Title: **WideLine rigging hardware torque adjustment**
Bulletin #: WLX0001 Issue Date: December 15, 2008
Models Affected: WideLine 8 Series and WideLine 10 Series
Bulletin Revision: B
Production Range: All before December 2007 (serial number 1107xxxx and earlier)

Figure 1. Removing the knuckle from the rigging channel.

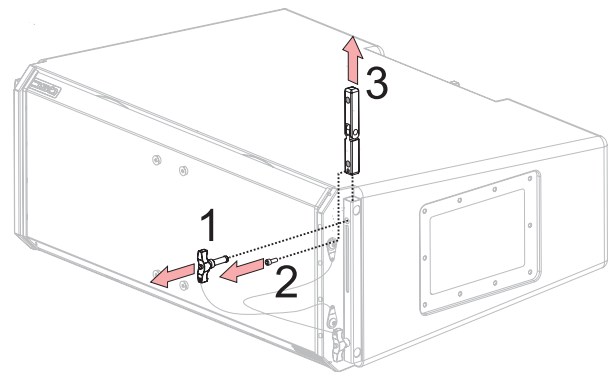
1. **WL2102-w and WL218-sw only:** Remove the knuckle from the rigging channel by first unscrewing the TORX cap head screw and then sliding the knuckle out (see Figure 1). Note the orientation of the knuckle, to ensure proper reinstallation at the completion of this procedure.
2. **All models:** Remove the TORX screws that hold the rigging channel or channels to the enclosure (two screws and one channel on the WL2102-w; four screws and one channel on the WL218-sw; four screws and two channels on the WL3082; six screws and two channels on the WL212-sw). Apply a dab of Loctite QuickStix 248 to the thread at the end of each screw. See Figure 2.
3. **All models:** Reinstall the screws through the rigging channel into the enclosure, using a power drill-screwdriver at its *lowest* torque setting to lightly secure the screws.

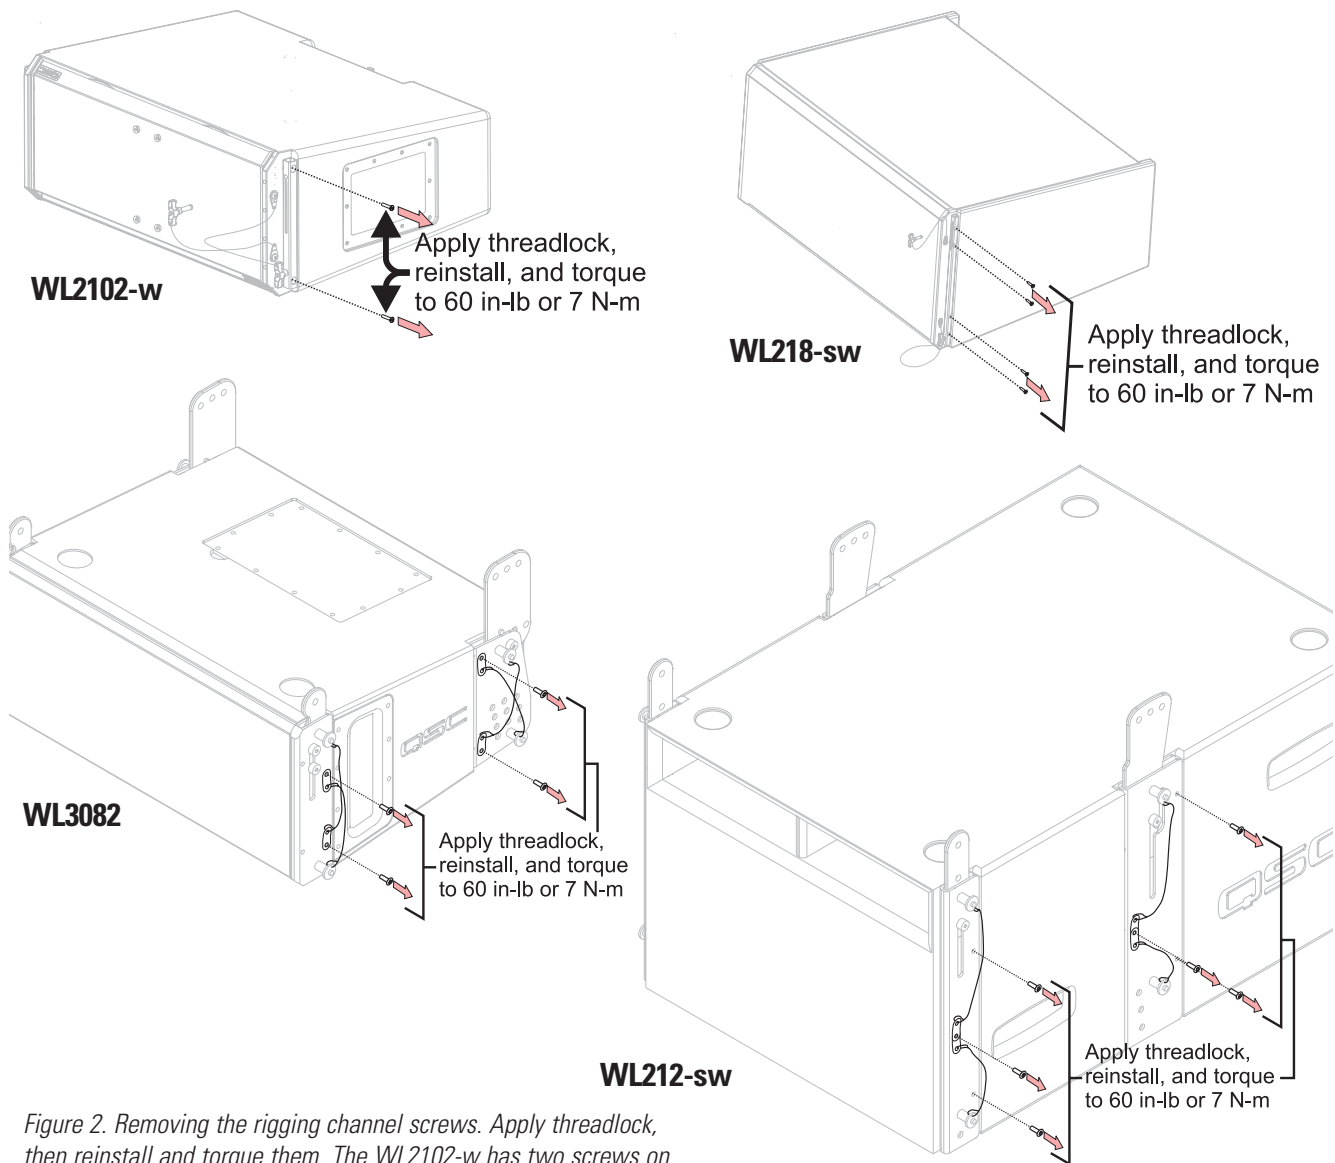
On the WideLine 8 WL3082 and WL212-sw cabinets, attach the anchors of the rigging pin lanyards as shown in Figure 2 when you reinstall the screws.

5. **All models:** Use the torque wrench, set to **60 in-lb** or **7 N-m**, to tighten the screws to the proper torque.
6. **WL2102-w and WL218-sw only:** Reinstall the knuckle into the channel, while making sure its orientation is correct (Figure 4). Fasten the cap head screw to the knuckle.

Figure 3. Removing the rigging bar screws. Apply threadlock, then reinstall and torque them. The WL3082 has three screws on each side, while the WL212-sw has two.

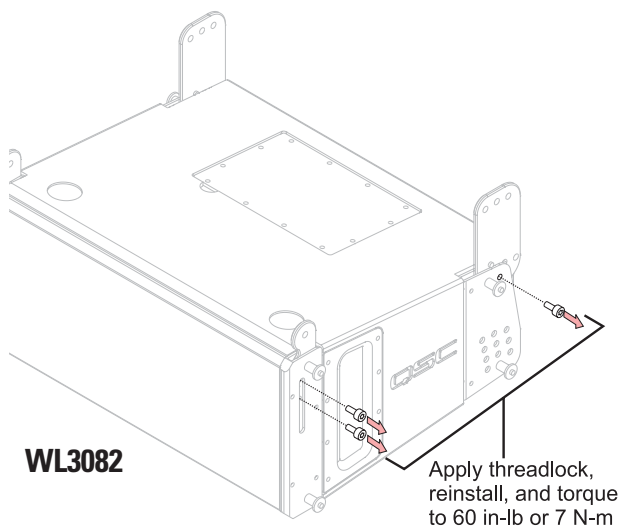
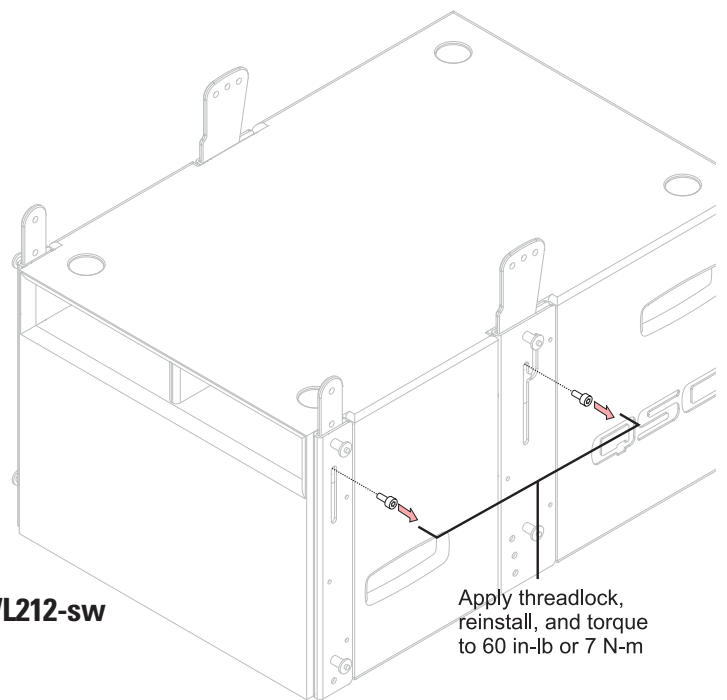
4. **WL3082 and WL212-sw only:** Remove the screws in the rigging bars (three screws on the WL3082; two screws on the WL212-sw). See Figure 3. These screws may have either TORX or Phillips heads. Apply a dab of Loctite QuickStix 248 to the thread at the end of each screw. Reinstall and lightly secure the screws using a power drill-screwdriver at its lowest torque setting.

Apply threadlock, reinstall, and torque to 60 in-lb or 7 N-m

Apply threadlock, reinstall, and torque to 60 in-lb or 7 N-m

Figure 5. Removing the 12 rear angle plate screws. Apply threadlock, then reinstall and torque them.

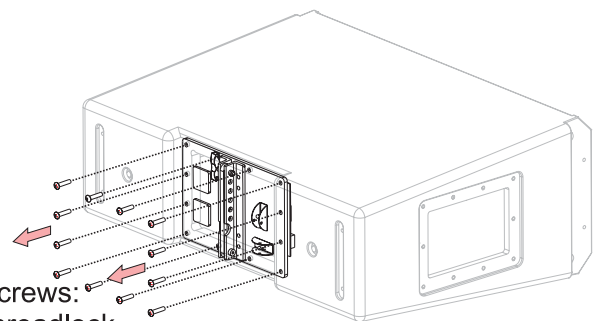
7. **All models:** Repeat steps 1 through 6 with the rigging channel or channels on the other end of the loudspeaker enclosure.
8. **WL2102-w and WL218-sw only:** Remove all twelve screws on the input plate/rear rigging point and apply Loctite QuickStix 248.

9. **WL2102-w and WL218-sw only:** Reinstall the screws using a power drill-screwdriver at its lowest torque setting to lightly secure the screws. Torque all of them to **60 in-lb** or **7 N-m** (Figure 5).

All 12 screws:
Apply threadlock, reinstall, and torque to 60 in-lb or 7 N-m
